REMARKS

Claims 1-12 were presented for examination with claims 1-3, 5-10 and 12 being rejected. Claims 4 and 11 are also identified as rejected but no grounds are stated. The drawings and specification have been objected to. This amendment amends all claims to better claim that which the applicant regards as the invention, adds claims 13-20, provides a new set of drawings for which approval is requested and provides a new specification. No new matter is involved.

In the Drawings:

Please amend the drawings by substituting the attached 6 replacement sheets for the original 6 sheets of drawings. The drawing changes are indicated in red in the attached Annotated Marked-up Drawings.

FIG. 1

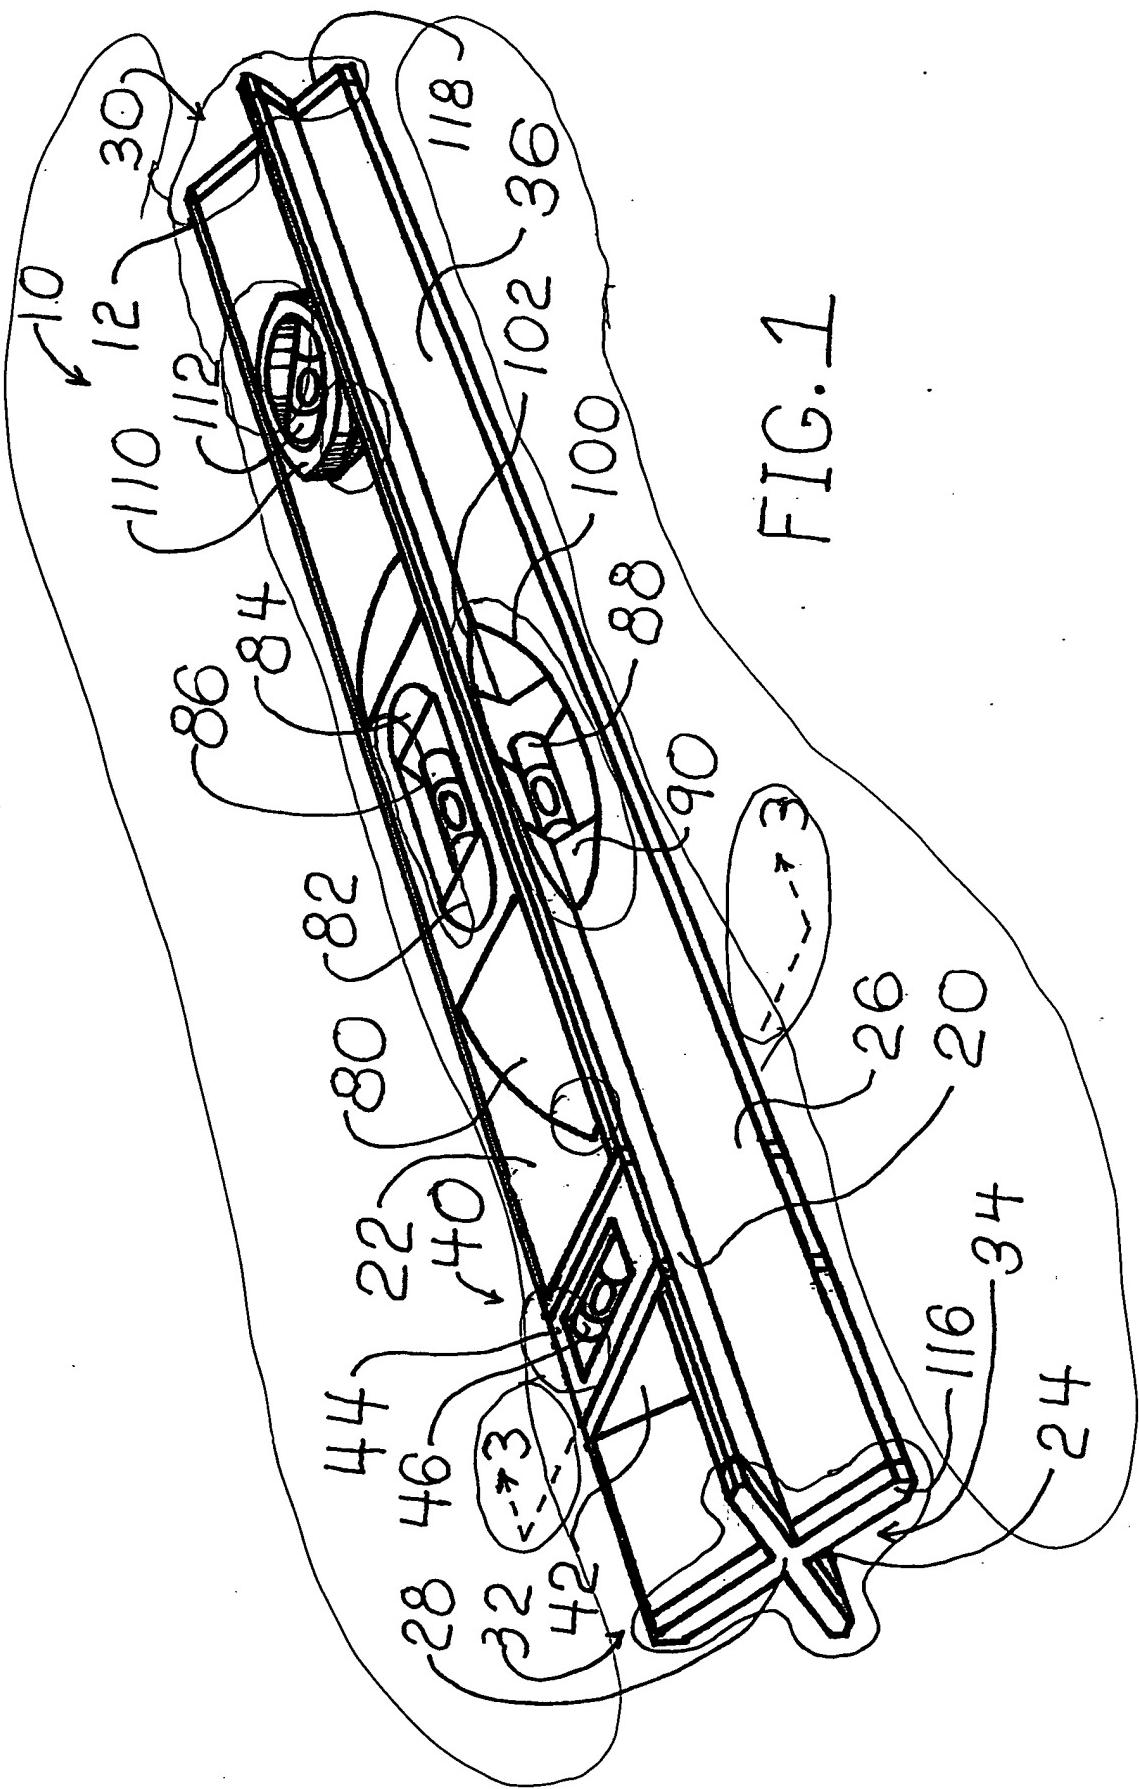
In Fig. 1 solid shading has been removed at several locations that have been encircled in red and the reference numerals have been changed to match the revised specification. Arrows have been added to illustrate the plane of the sectional view of Fig. 3.

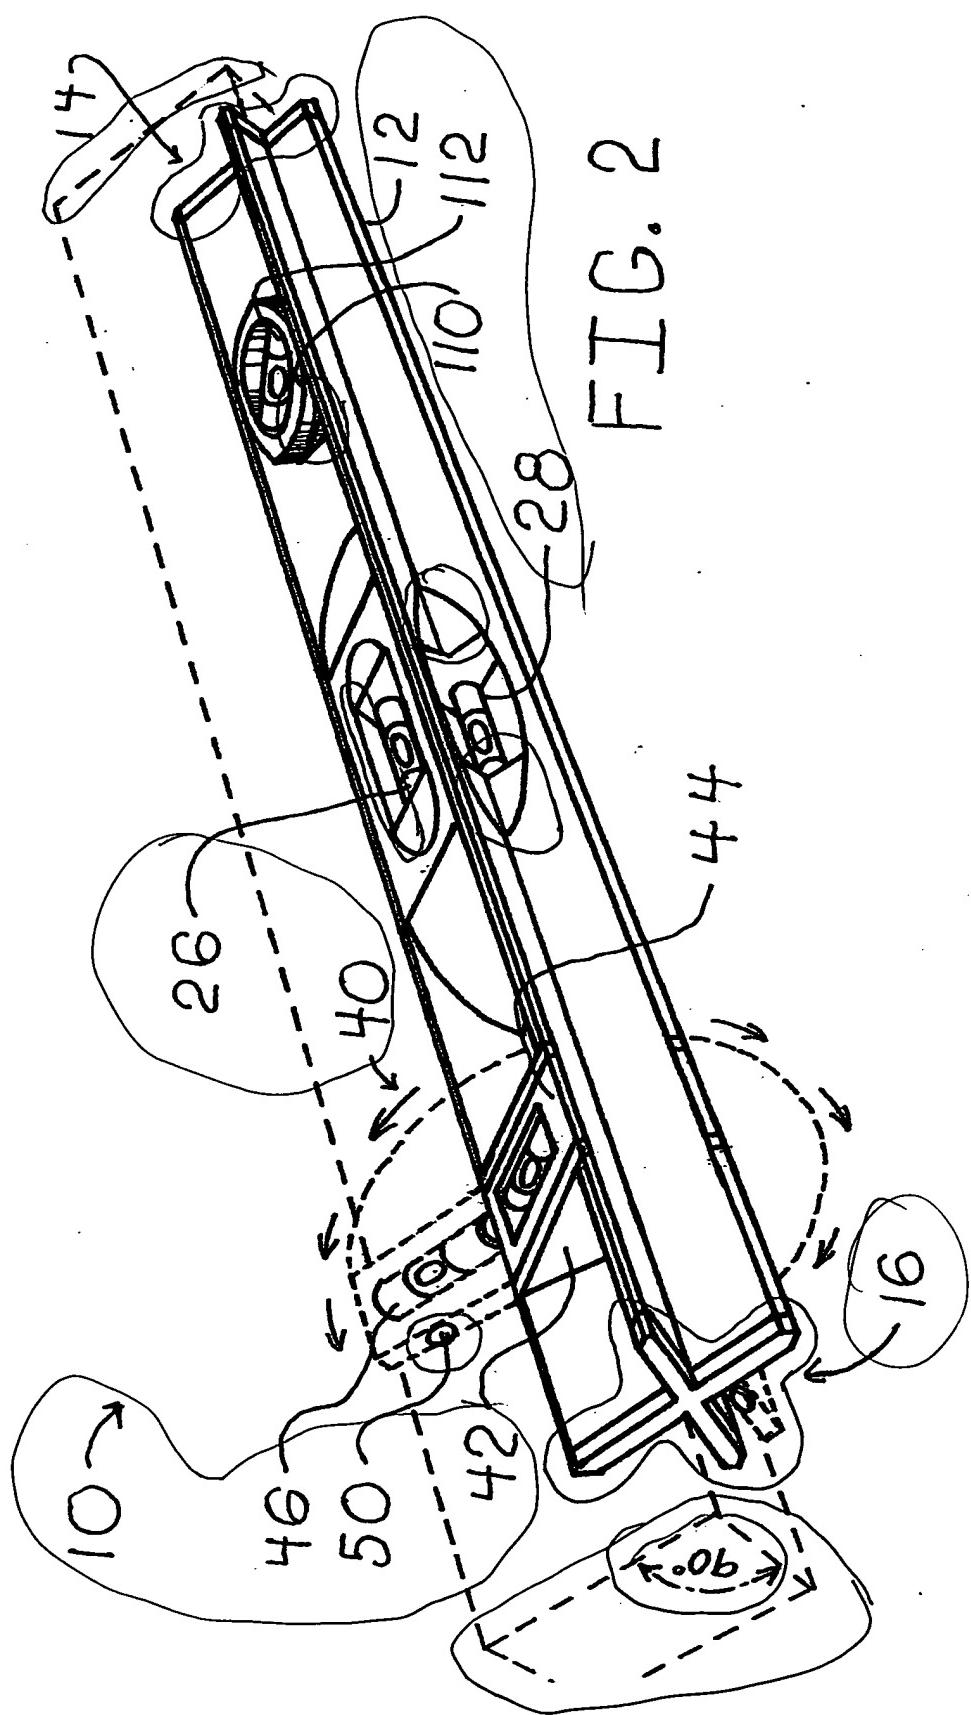
In Fig. 2 solid shading has been removed at several locations that have been encircled in red and the reference numerals have been changed to match the revised specification. The work piece has been shown in all dashed line outline, the erroneous "45-degree" indication has been corrected to --90-

degrees-- and the word "post" has been removed. The orientation of the reference numerals and figure number have been changed to provide consistency with Fig. 1.

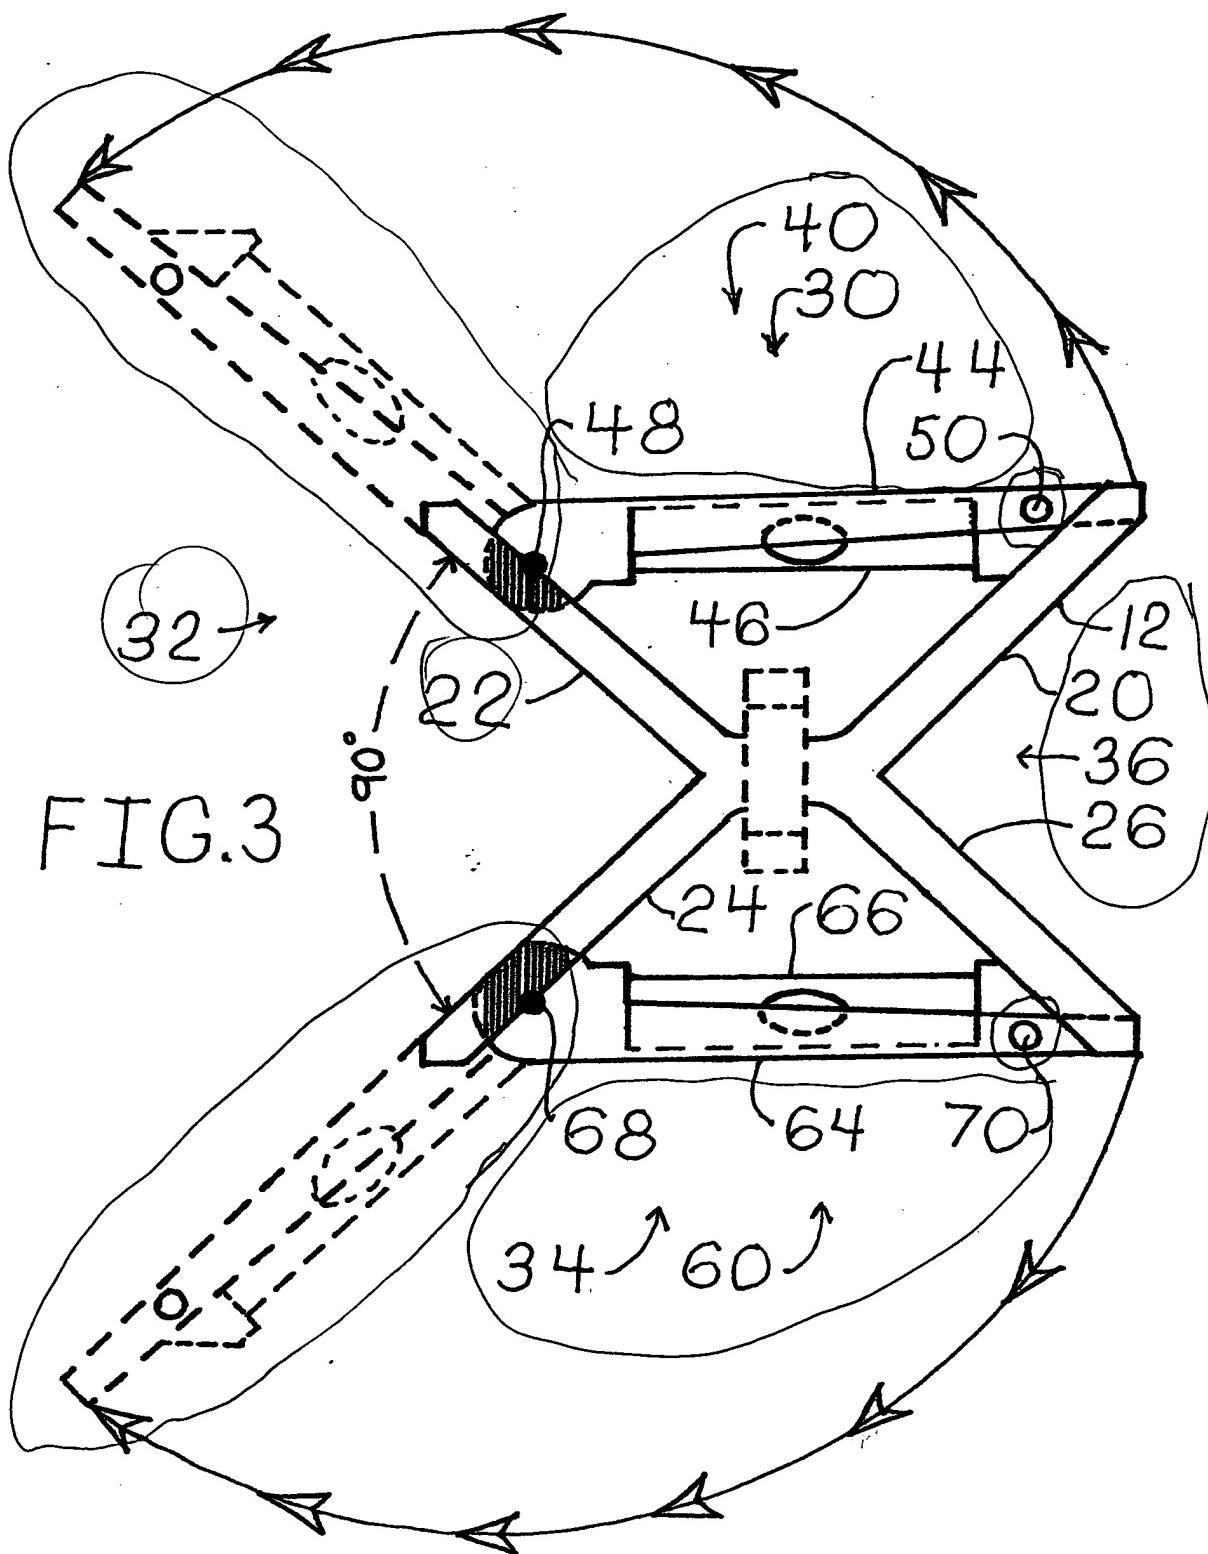
In Fig. 3 solid shading has been removed at several locations that have been encircled in red and the reference numerals have been changed to match the revised specification. The orientation has been inverted to provide consistency with Figs. 1 and 2, and alternative extended positions of the flip out brackets and bubble vials have been shown in dashed outline instead of solid outline.

FIG. 4

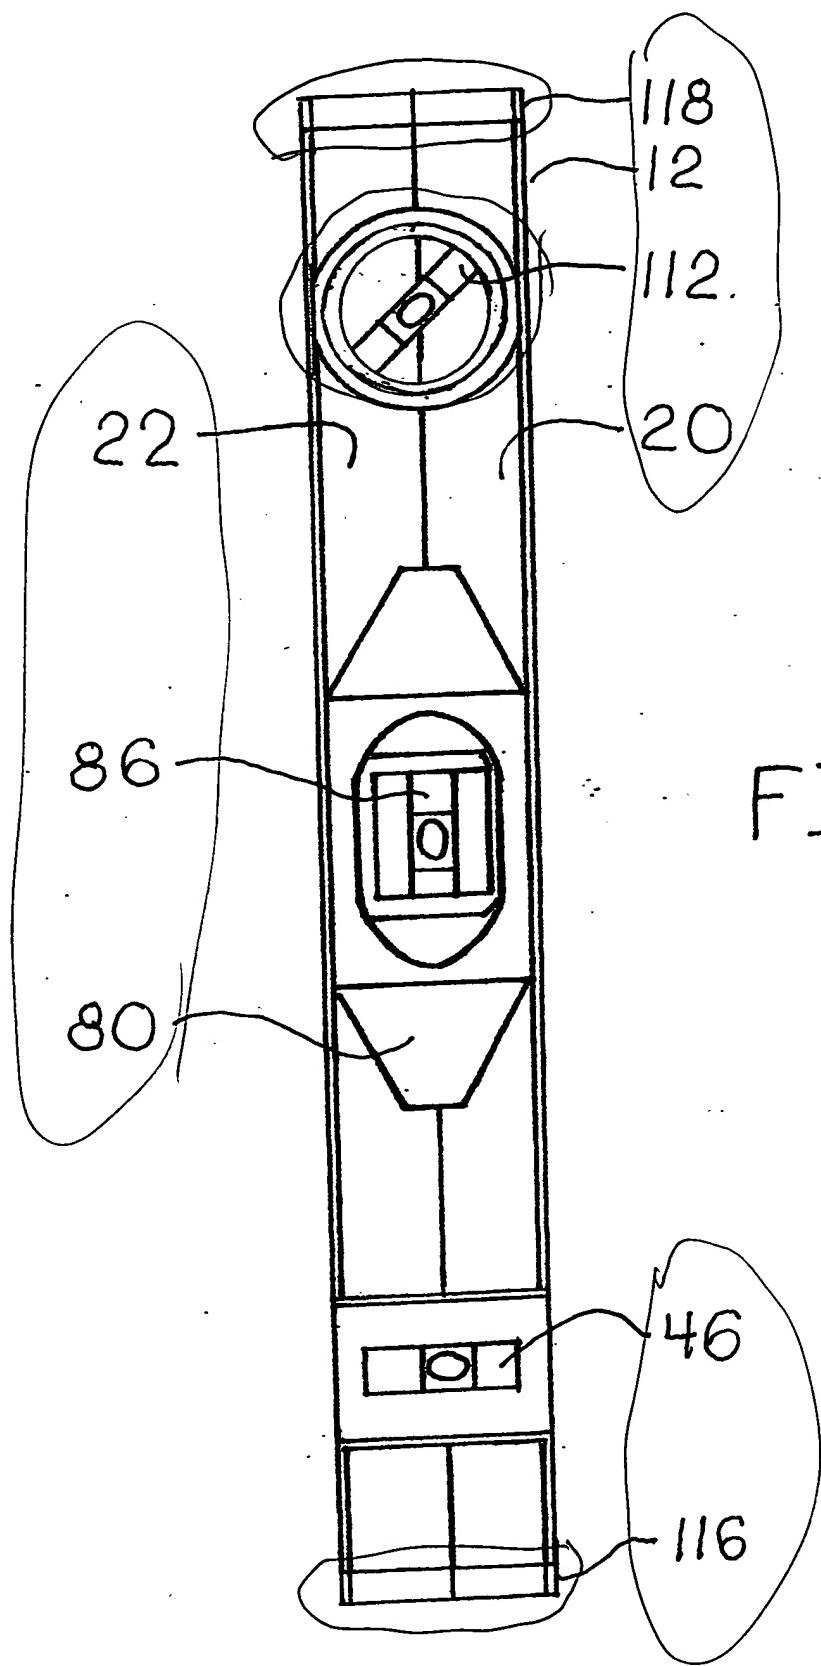
In Fig. 4 solid shading has been removed at several locations that have been encircled in red and the reference numerals have been changed to match the revised specification. The orientation has been inverted to provide consistency with Fig. 1, 2 and 3.

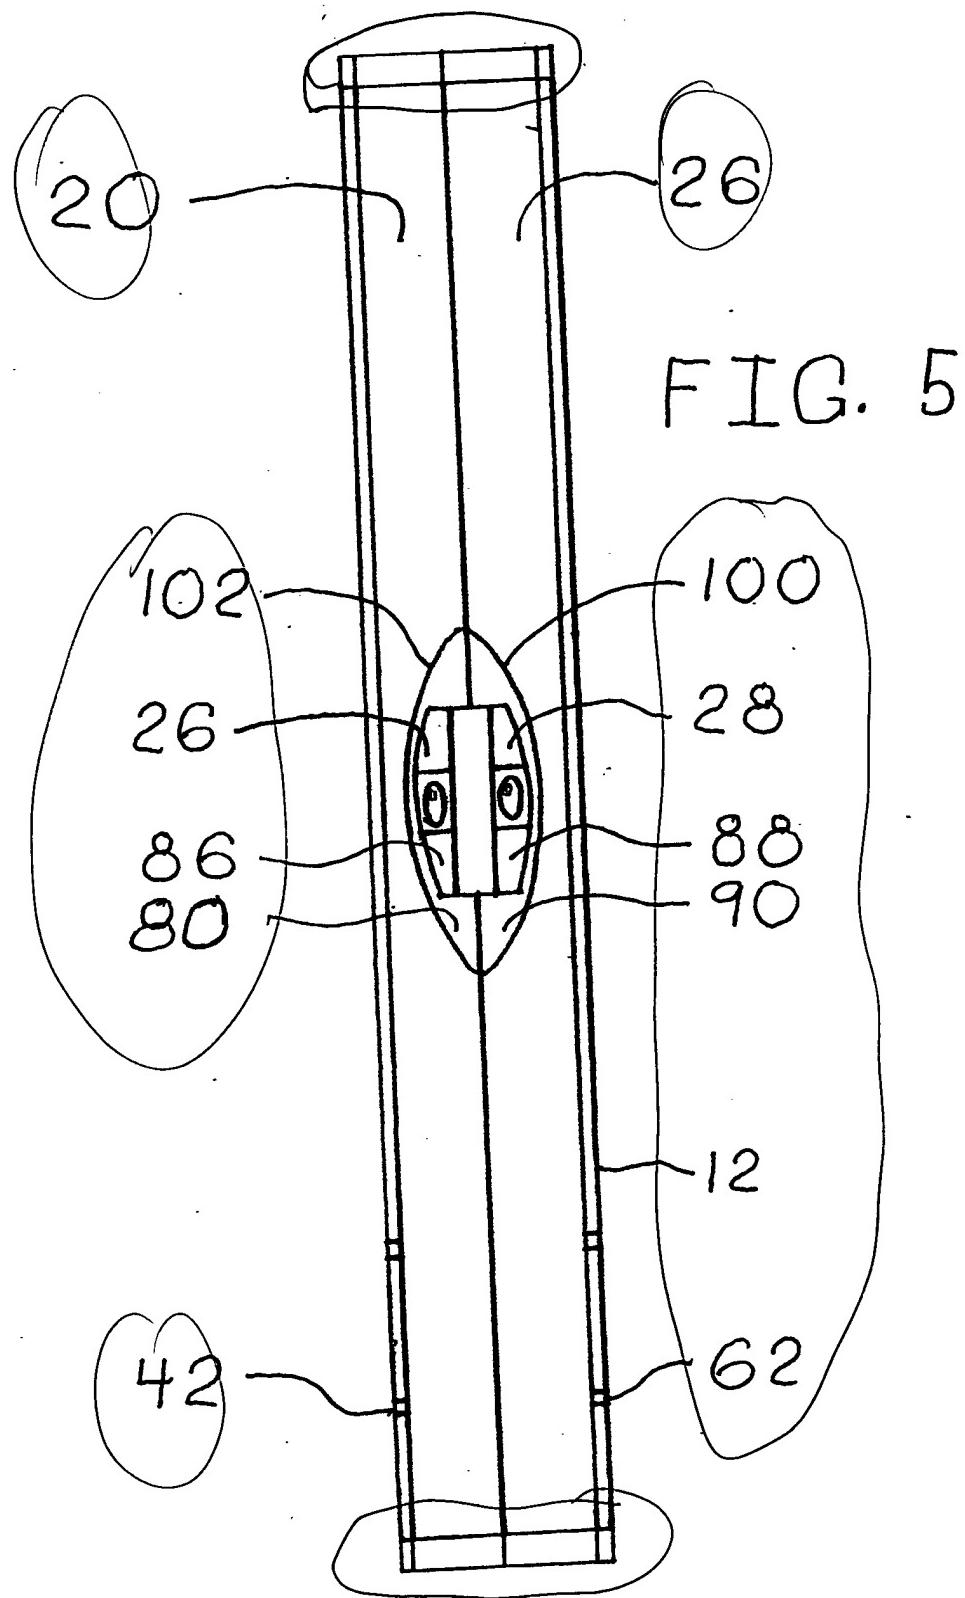
In Fig. 5 solid shading has been removed at several locations that have been encircled in red and the reference numerals have been changed to match the revised specification. The orientation has been inverted to provide consistency with Fig. 1, 2, 3 and 4.

FIG. 6

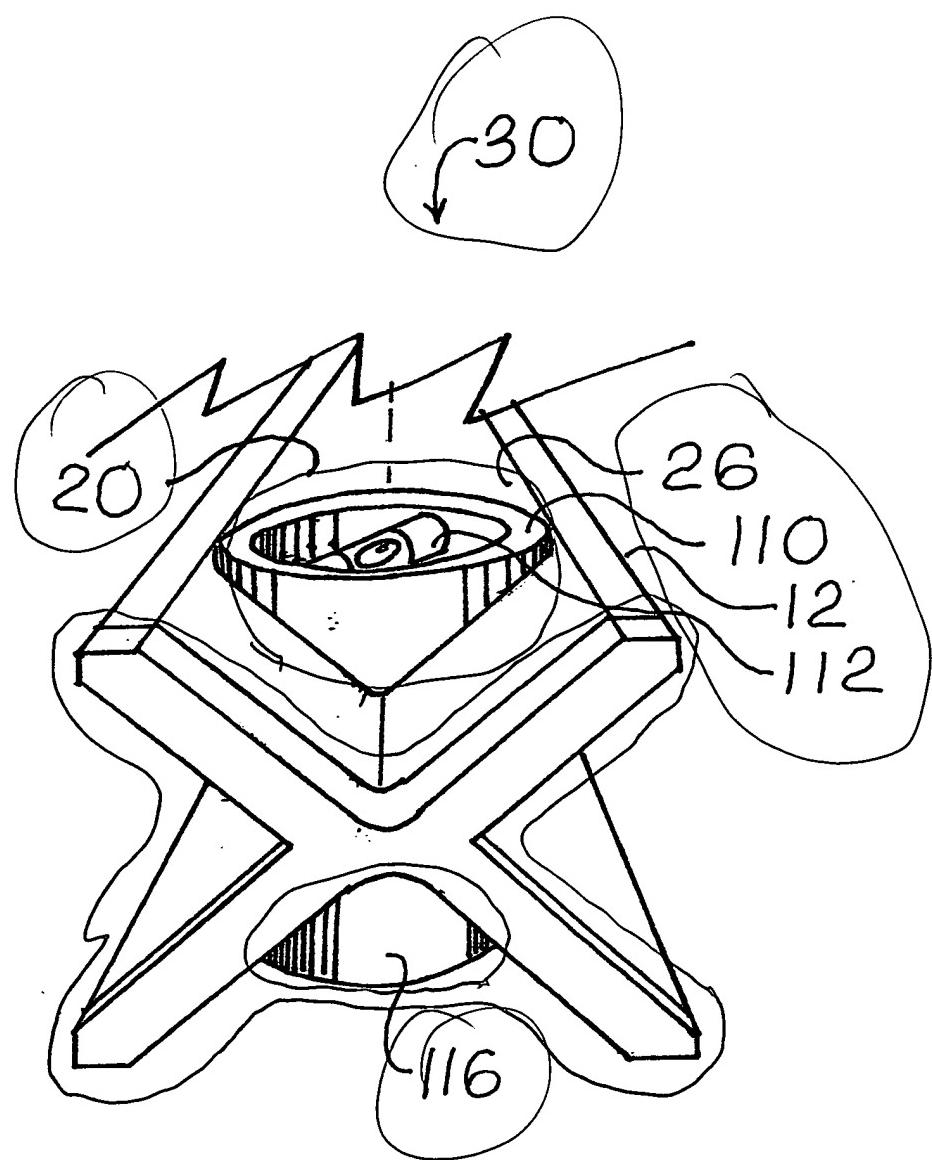
In Fig. 6 the shading has been modified as shown in red and an end cap has been shown as encircled in red for consistency with Figs. 1-5. The reference numerals have been changed to match the revised specification.
